UNITED STATES ENVIRONMENTAL PROTECTION AGENCY  
REGION V

SUBJECT: ACS NPL Site  
Groundwater Modeling

FROM: Dr. Luanne Vanderpool, Geologist  
Technical Support Section

Eileen Helmer asked that I review the Groundwater Modeling Results, Appendix A, of the Draft Feasibility Study for American Chemical Services (ACS) NPL Site. The Feasibility Study has stated on page 3-18, "Groundwater extraction associated with the pump and treat system would not be expected to affect wetlands hydrology based on modeling results presented in Appendix A." Eileen asked me to determine if this statement is true.

Figure 1

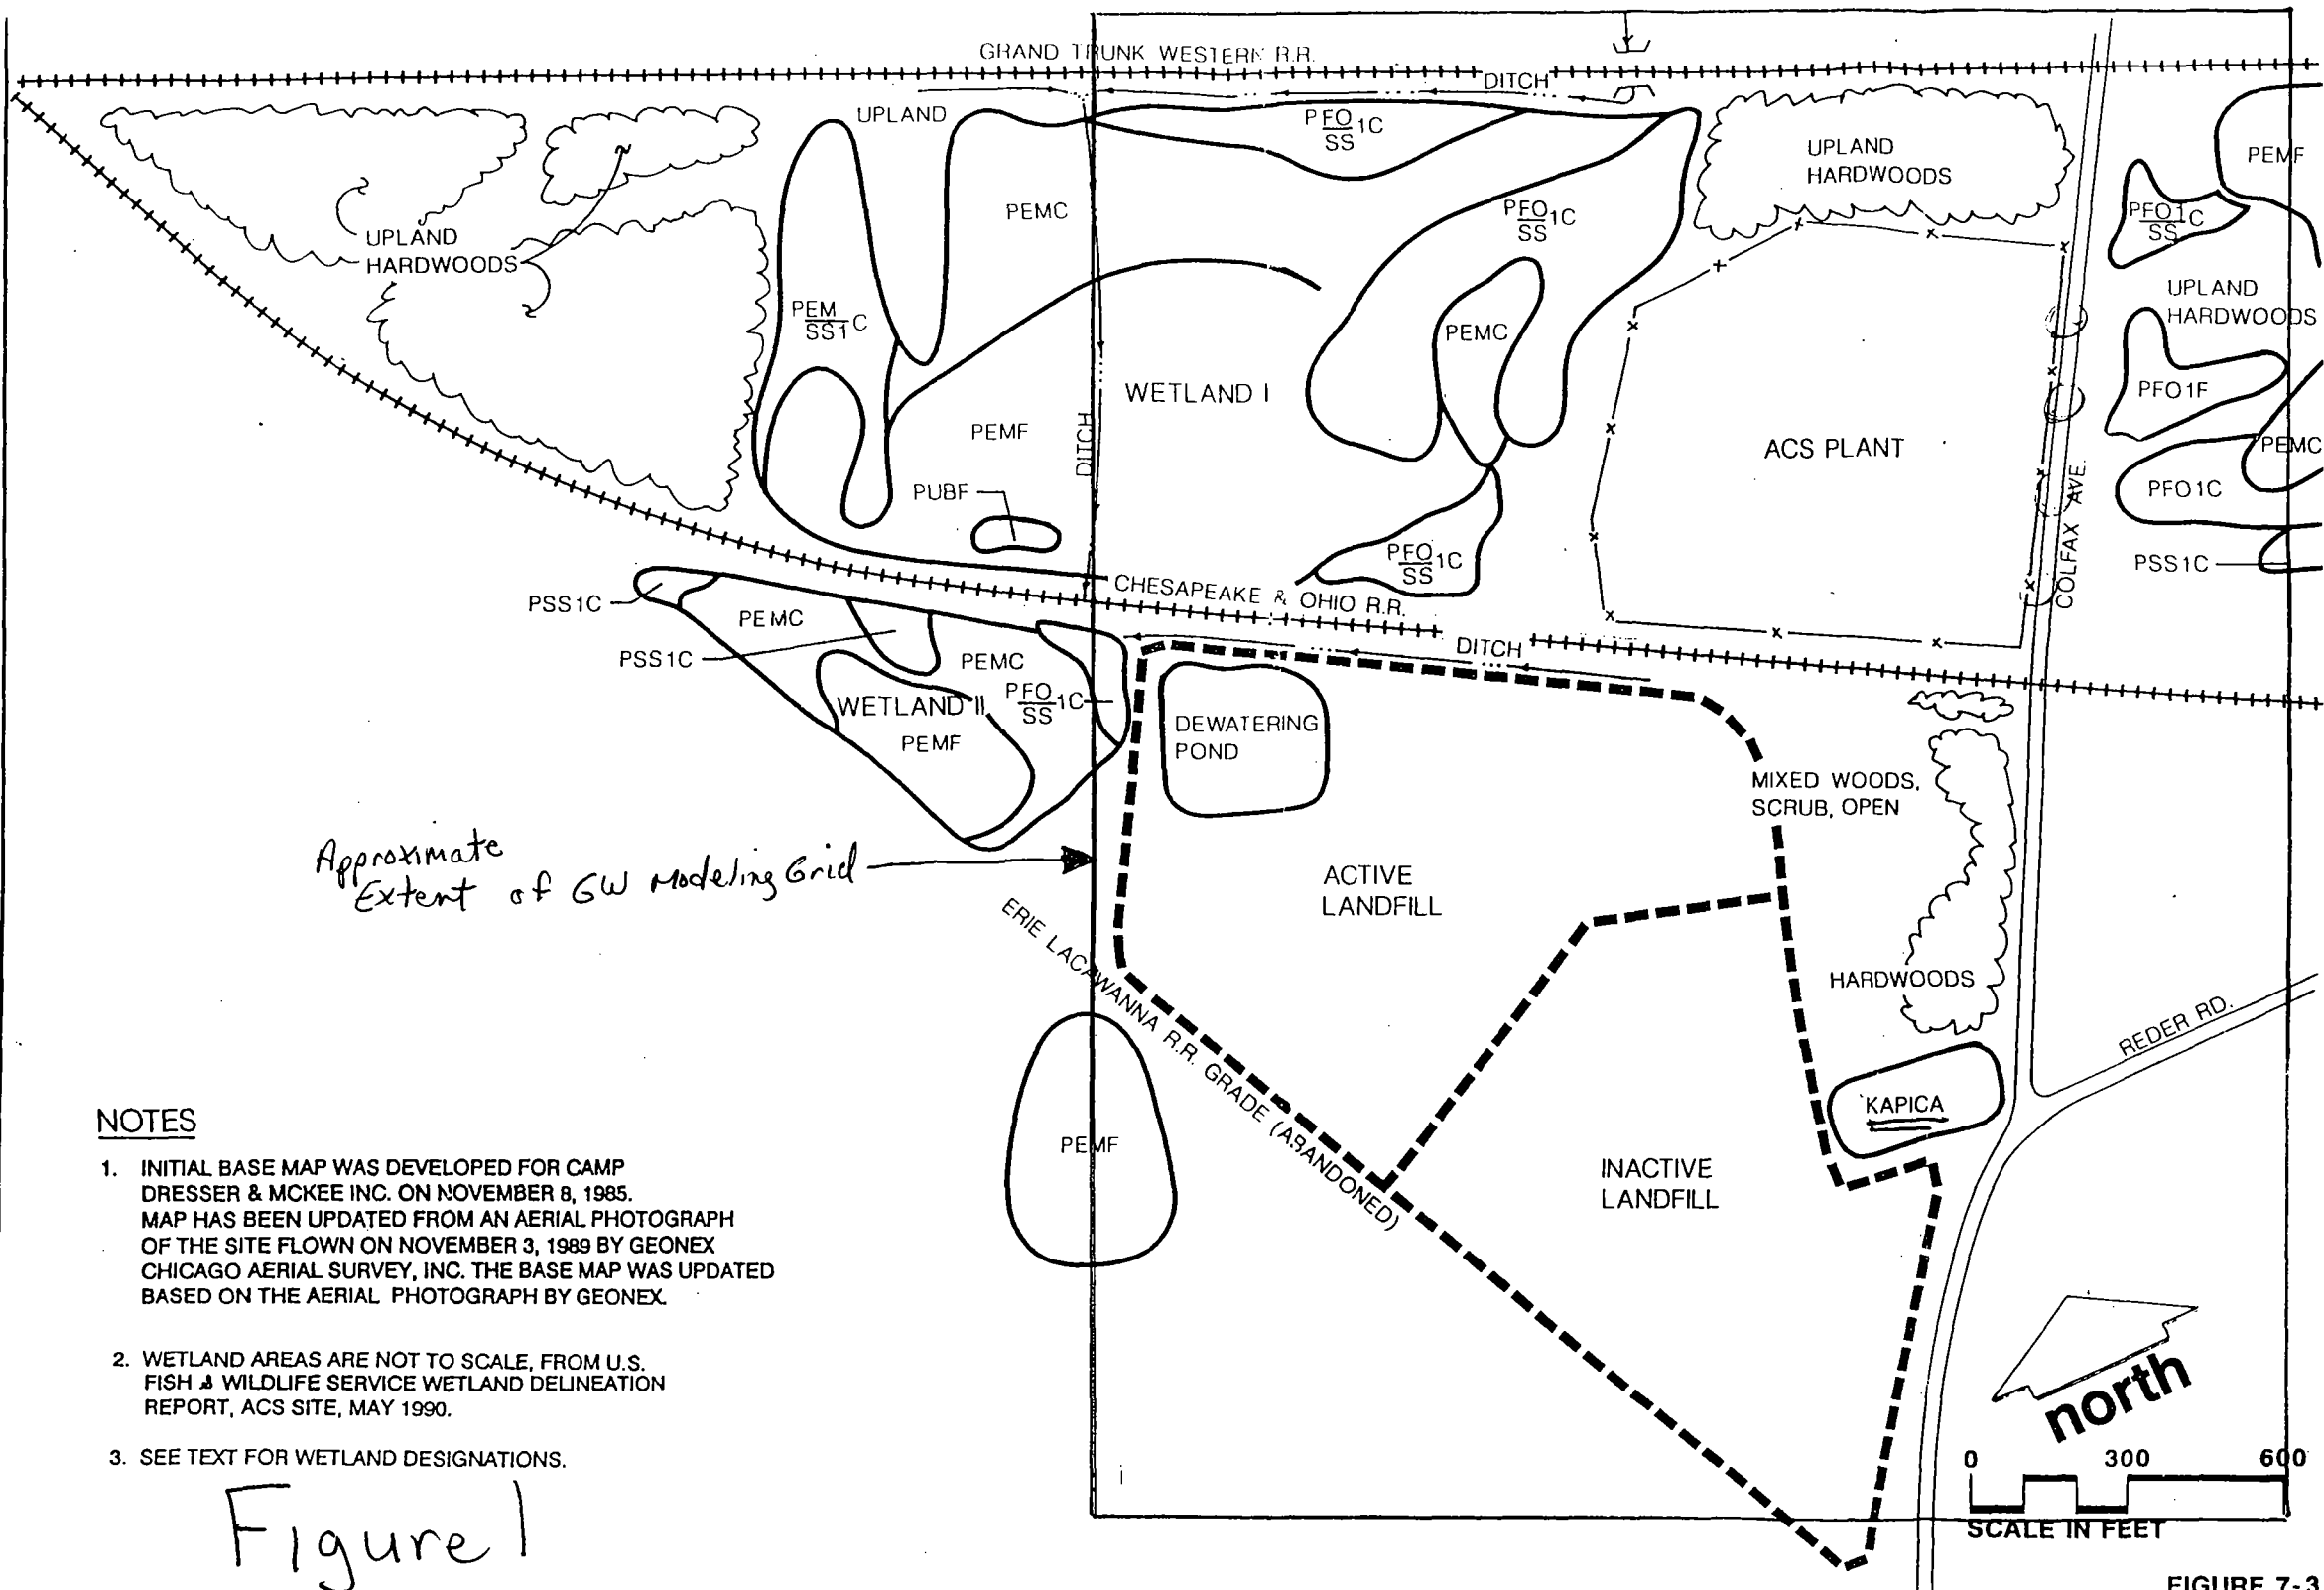
The modeling report in Appendix A omits any map which shows the modeling grid in relation to the surface water features around the site. Attached is a copy of a figure from the RI (Ecological Features) with the approximate extent of the groundwater modeling grid outlined on it (Figure 1). The same area was modeling in both the upper aquifer modeling and the northwest area remediation modeling. As can be seen from the attached figure, Wetland II, located west of ACS, is outside the modeling area; and no conclusions about this area can be made based on the models. Similarly, the western half of Wetland I is beyond the modeling and no conclusions can be made. Conclusions are only possible for the eastern half of Wetland I and the Upland Hardwoods area east of the site.

Figure 2

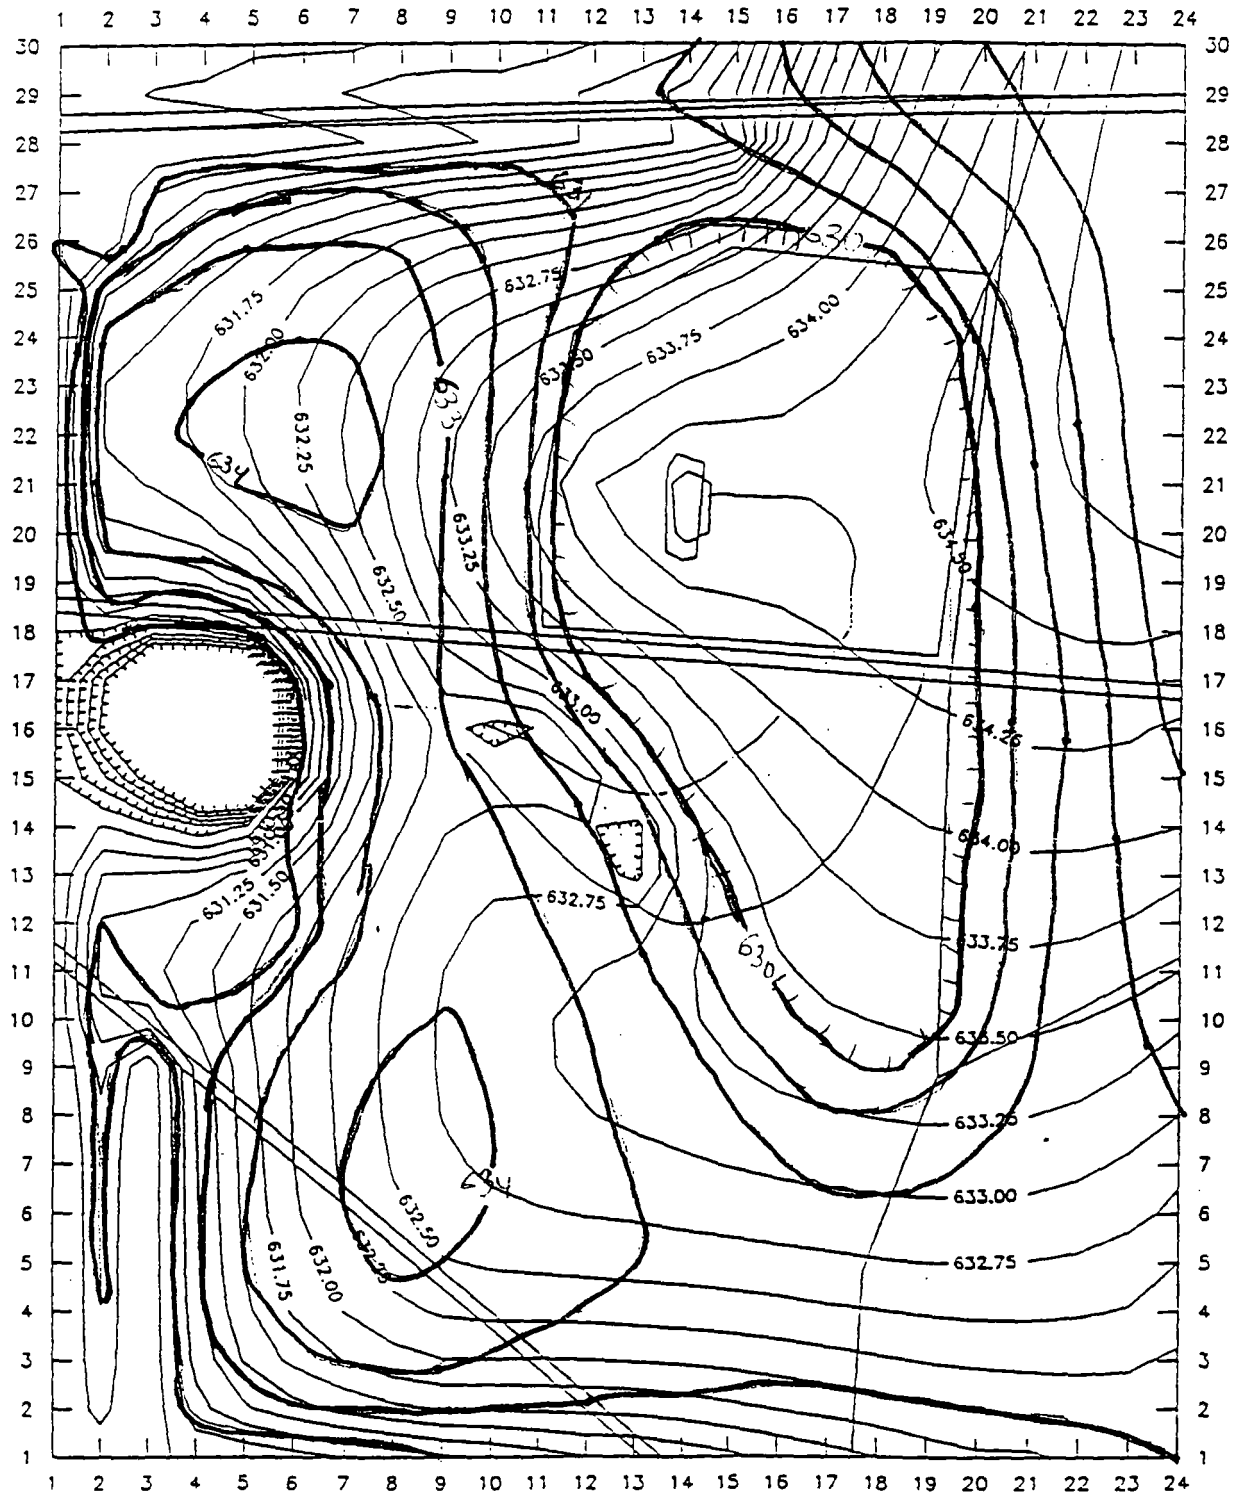
The "Steady-state Non-Remediation Flow Conditions" map may be compared to maps showing the upper aquifer remediation scenarios modeled after 365 days (see attached Figures 2 and 3). Interestingly, the western half of the modeled Wetland I has a higher water table (up to over 2 feet) under the remediation scenarios. The eastern portion of this wetland has a lower water table (up to 2 feet head difference) under the remediation scenarios. In the case of the no slurry wall alternative, the zone of lowered water table in Wetland I is larger than for the alternative with the slurry wall. The water table is lowered in

the Upland Hardwoods area also; the area impacted is larger for the non-slurry wall alternative. }

Figure 4

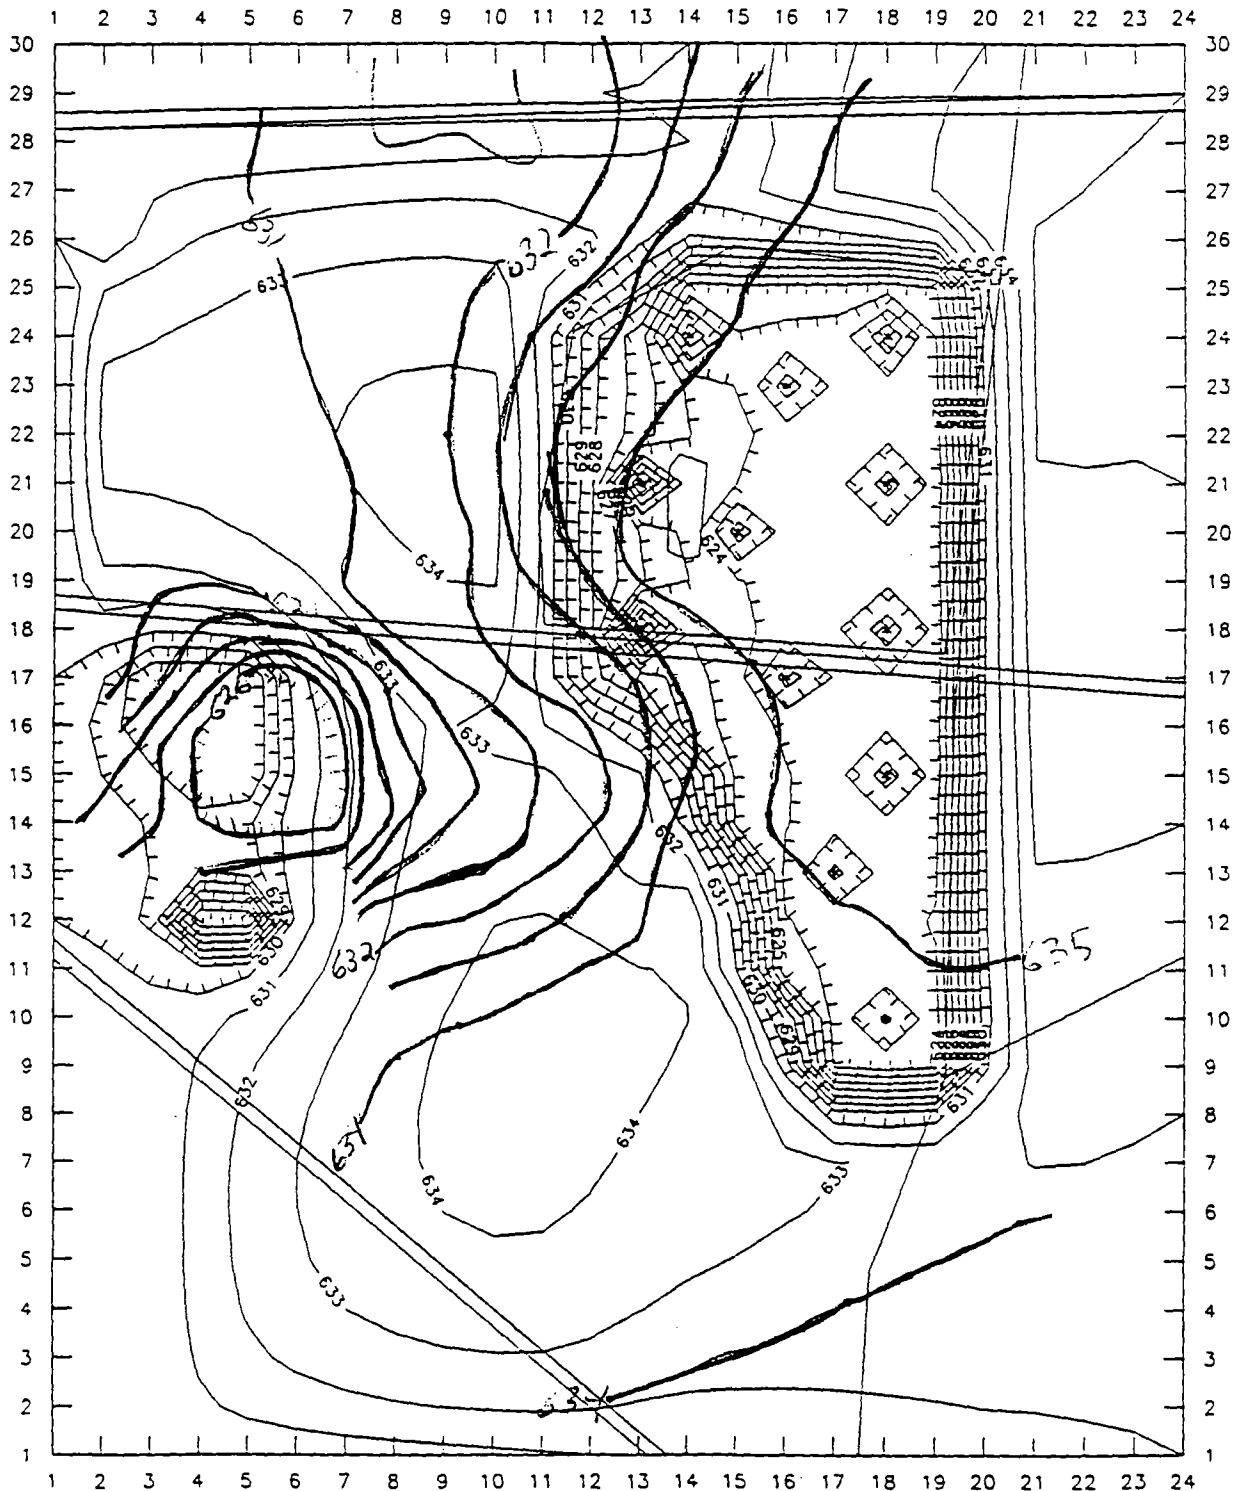
Comparing the groundwater model results to the water table map of April 6, 1990 (Figure 1-12) yields the following conclusions (see attached Figures 4 and 5). Water levels are higher for both the slurry wall alternative and the no slurry wall alternative in Wetlands I. Modeled water levels (with and without the slurry wall) are lower in the Upland Hardwoods area.

I find it of some concern that modeled water levels under a pumping alternative (with or without a slurry wall) are so much higher than measured water levels in Wetland I. Common sense would suggest that the impact of groundwater withdrawal would be to lower water levels, not elevate water levels up to 3 feet. I suspect this difference in water levels is largely a reflection of poor calibration in the modeling of this area (and possibly incorrect boundary conditions), not a real effect due to the groundwater pumping. }
